PJM Manual 14D:

Generator Operational Requirements

Revision: ~~6866~~

Effective Date: ~~July 23, 2025~~
~~December 18, 2024~~

Exhibit 7: Metering requirements example for a Mixed Technology Facility

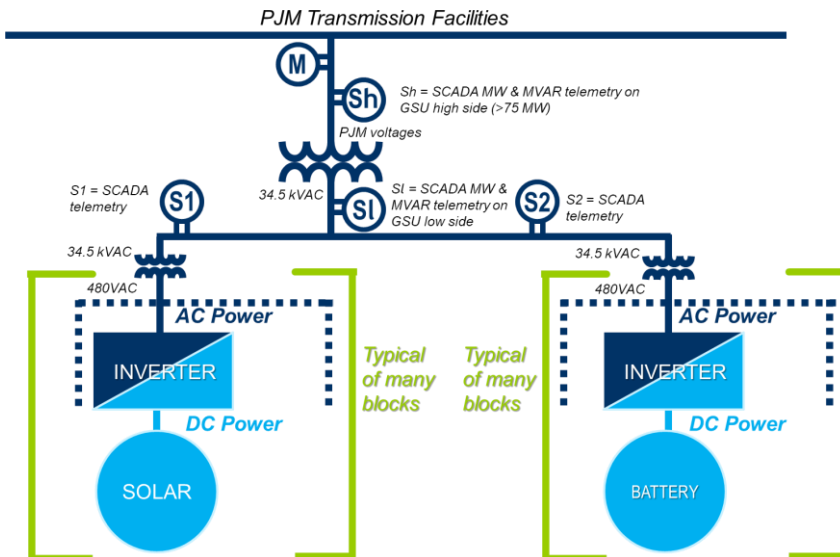
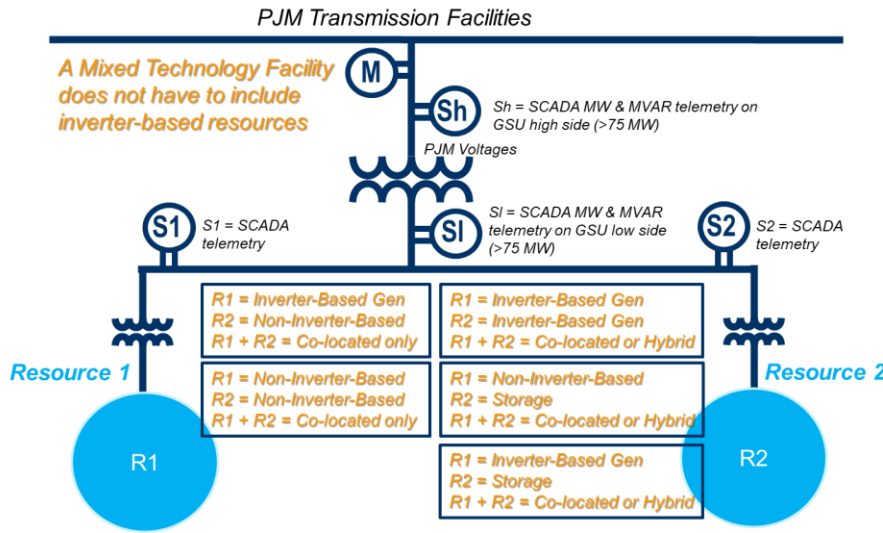
Exhibit 7 below illustrates ~~an~~ general example of a Mixed Technology Facility with combinations of inverter-based (including storage) or non-inverter-based resources~~a solar resource and an Energy Storage Resource~~, each participating separately in markets as a Co-Located Resource. In this example, all of the energy measured for the Mixed Technology Facility at "M" across an interval (e.g., 5 minutes) is split between the combination of resources~~solar resource and the Energy Storage Resource~~ pro rata according to the power measured at S1 (which measures all of the R1 power flows~~solar production~~) and at S2 (which measures all of the R2 power flows~~storage power flows~~) integrated over the interval.

An example of real-time data and account metering requirements for a Mixed Technology Facility, including measurement points. ~~This facility is 75 MW or larger and participates in PJM markets as a single Hybrid Resource.~~ More or fewer measurement points may be required depending on circumstances; see Mixed Technology Facility business rules immediately above for more detail.
